**BROWNS FERRY NUCLEAR PLANT (BFN) UNIT 1 - RESPONSE TO NRC
REQUEST FOR ADDITIONAL INFORMATION REGARDING INDIVIDUAL PLANT
EXAMINATION OF EXTERNAL EVENTS (IPEEE) FOR SEVERE ACCIDENT
VULNERABILITIES - SUBMITTAL OF BROWNS FERRY NUCLEAR PLANT
UNIT 1 SEISMIC AND INTERNAL FIRES IPEEE REPORTS
(TAC NO. MC5729)**

TENNESSEE VALLEY AUTHORITY BROWNS FERRY NUCLEAR PLANT (BFN) UNIT 1

RESPONSE TO NRC REQUEST FOR ADDITIONAL INFORMATION INDIVIDUAL PLANT EXAMINATION FOR EXTERNAL EVENTS

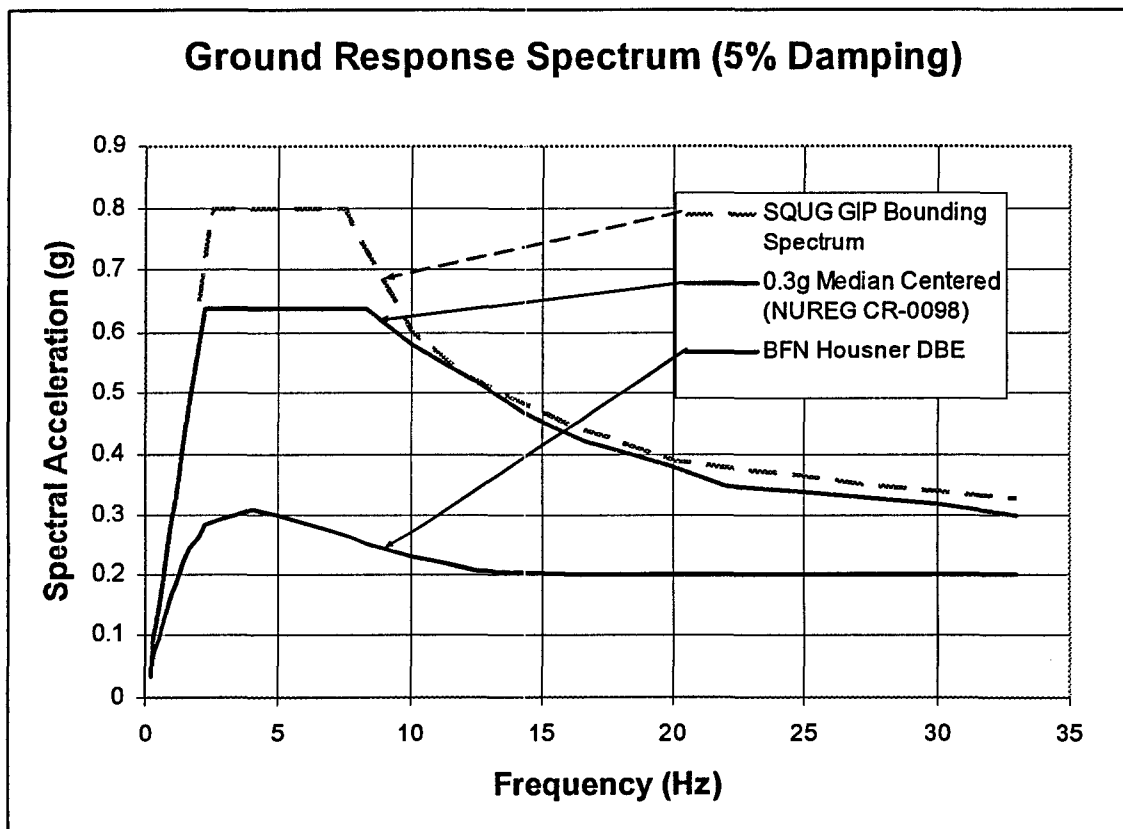
Please provide a graph of the Review Level Earthquake (RLE) spectra used for the seismic margin assessment (SMA). On the same graph also provide the site Design Basis Earthquake (DBE) ground spectra (Housner spectra with 0.2g peak ground acceleration), and the USI A-46 spectra.

Discuss whether there is any exceedance of DBE or USI A-46 spectra over the RLE spectra in the frequency range of interest for the BFN Unit 1 systems, structures, and components (SSCs).

Browns Ferry is a 0.3g focused scope plant for seismic IPEEE. The RLE ground motion response spectrum is based on 0.3g NUREG CR-0098 median spectral shape. The DBE is 0.2g Housner shaped spectrum. The DBE spectra were used for the USI A-46 evaluations. These spectra were defined as median centered for the A-46 evaluations, per the SQUG GIP. A comparison of the DBE and IPEEE ground motion response spectra is shown below. The IPEEE ground motion response spectrum fully envelopes the DBE ground motion response spectrum. The SQUG GIP Bounding Spectrum is also shown for information. The SQUG GIP Bounding Spectrum fully envelopes both the DBE and the IPEEE spectra.

Seismic IPEEE floor response spectra were determined by scaling up the DBE floor response spectra by a factor of 1.88 for the Reactor Building (see TVA Calculation No. CD-Q0000-940339, "Calculation of Basic Parameters for A-46 and Individual Plant Examination of External Events (IPEEE) Seismic Program," Rev. 1, sheet 49; Enclosure 2 of this submittal).
